6 VISUAL IMPACTS

Visual Impact: Flyers Creek Wind Turbine Awareness Group (FCWTAG) objects to the Flyers Creek Wind Farm proposal:

Figure 6.1: Comparison of Blayney Wind Farm turbines and a photomontage of wind turbines proposed for Flyers Creek Wind Farm

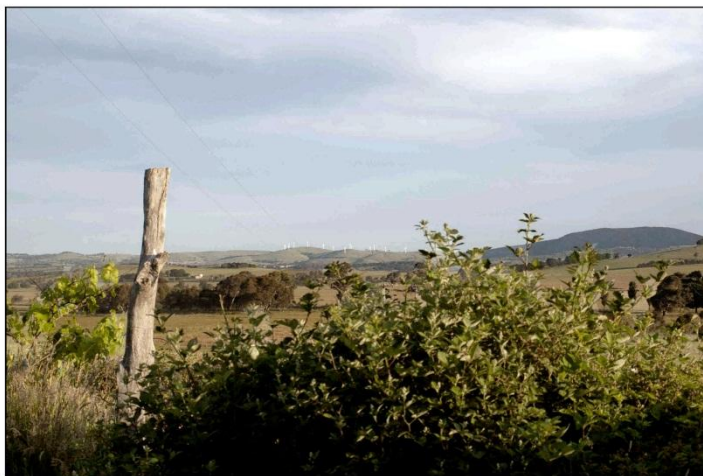
- 6.5.1 Visual impact of a wind turbine development is a major consideration. While distance and scale of the landscape can produce different perceptions of the impact on the landscape the human eye is often drawn to ‘artificial’ vertical features, regardless of distance, making them seem bigger. This is something that cannot be reproduced in a photomontage especially when a wide angle lens is used where the superimposed wind turbines will seem more distant, particularly in the centre of the picture. The photomontages give a sense of turbines that have been “faded out” and therefore we feel are not a true representation of the final visual impact.

Image 1 : Shot taken from Willowdale toward the existing turbines at Carcoar. These turbines are 67 meters high and 12 - 15 kilometers away and are clearly visible. (This shot is slightly to the left of the EA shot below)

Image 2: View of same area in infigen's EA. These turbines are 150 meters high and the closest of them are 1.3 to 1.8 kilometers away yet we can hardly see them.

Figure 6.2: Map showing flicker effects on the Flyers Creek Wind Farm, with white labelling removed. As a consequence the flicker patterns are more legible. Query the cropped areas as indicated above.

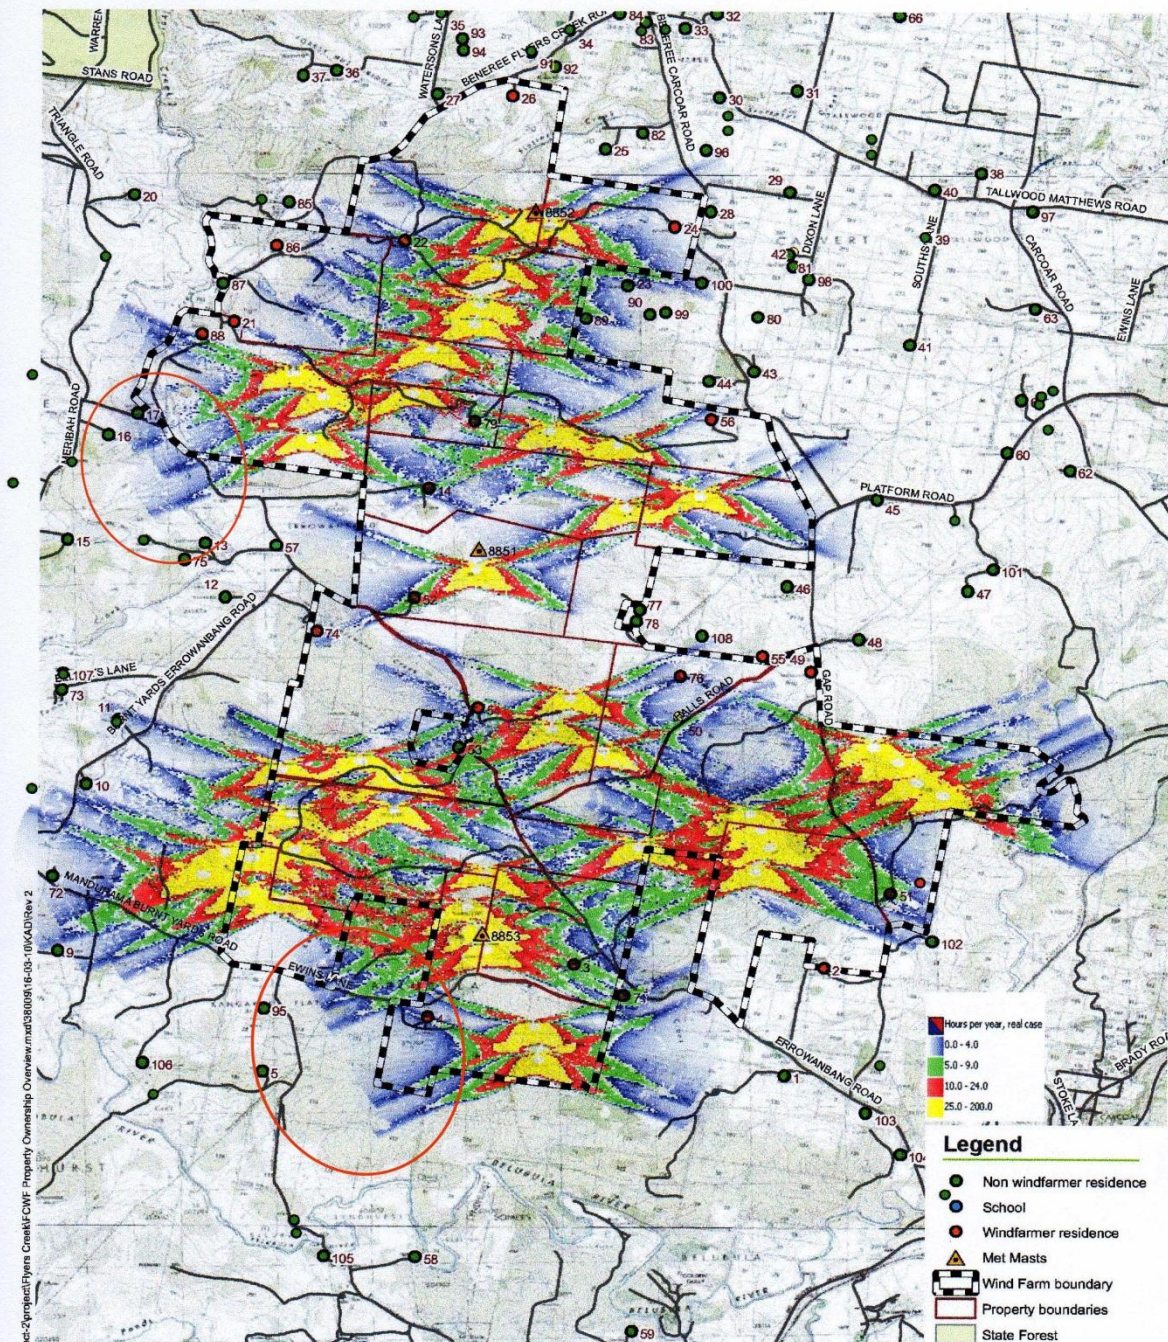
- 6.4.6 The map provided by PB Australia is particularly hard to read because of white boxes and black lettering which obliterate much of the information underneath. A map has been requested from PB Australia, without boxes and lettering. PB Australia was only willing to provide the map with Infigen's permission, which has only recently been forthcoming (Figure 6.1) . This goes towards **poor community consultation and transparency or worse**.

* Oval areas show where the blue shadow ends abruptly (appears to have been cropped.)
